# Access Compliance Report

### (Curb Ramps)

Intersection ID: 23574	Main Street: CARMEL_RD	Cross Street: QUAIL_HOLLOW_RD	Location: W
ADA ID: 0CF7E6D84816	Ramp Type: Perp	Initial Pass/Fail: Fail	Overall Compliance: No
Severity Score: 33.75			
Codes/Mitigation Info/Possible Solution		Field Measurements/Component Compliance

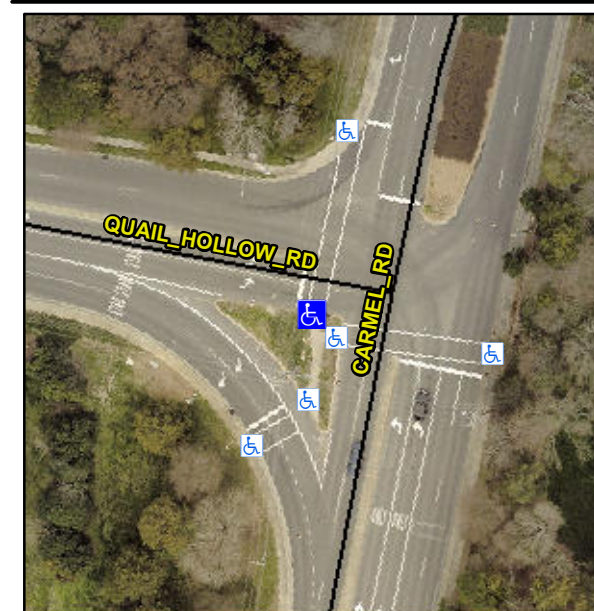
**R304.5.1, R304.2.2, R304.5.3**

Compliance	Description	Data	Compliance	Description	Data
N/A	Ramp Length (in)	58.0	No	Ramp Slope (%)	8.5
No	Ramp Width (in)	41.0	No	Ramp XSlope (%)	6.8
N/A	Flare Type LT	N/A	N/A	Flare Type RT	N/A
N/A	Flare Slope LT (%)	N/A	N/A	Flare Slope RT (%)	N/A
N/A	Flare Traversable LT?	N/A	N/A	Flare Traversable RT?	N/A
N/A	Landing Length (in)	N/A	N/A	DWS Provided?	N/A
N/A	Landing Width (in)	N/A	N/A	DWS Contrast?	N/A
N/A	Landing Slope (%)	N/A	N/A	DWS Length (in)	N/A
N/A	Landing X Slope (%)	N/A	N/A	DWS Full Width?	N/A
N/A	Landing Curb? (Y/N)	N/A	N/A	DWS Offset (in)	N/A
N/A	Shared Landing?	N/A			
N/A	Gutter Ponding?	N/A	N/A	Gutter Slope (%)	N/A
N/A	Gutter Lip Ht (in)	N/A	N/A	Gutter X Slope (%)	N/A
N/A	Painted X Walk1?	Yes	N/A	Painted X Walk2?	N/A
	X Walk 1 Direction	To N		X Walk 2 Direction	N/A
N/A	X Walk 1 Width (in)	94.0	N/A	X Walk 2 Width (in)	N/A
	X Walk 1 Slope (%)	1.5		X Walk 2 Slope (%)	N/A
	X Walk 1 X Slope (%)	1.2		X Walk 2 X Slope (%)	N/A

**Remove & Replace Entire Ramp.**
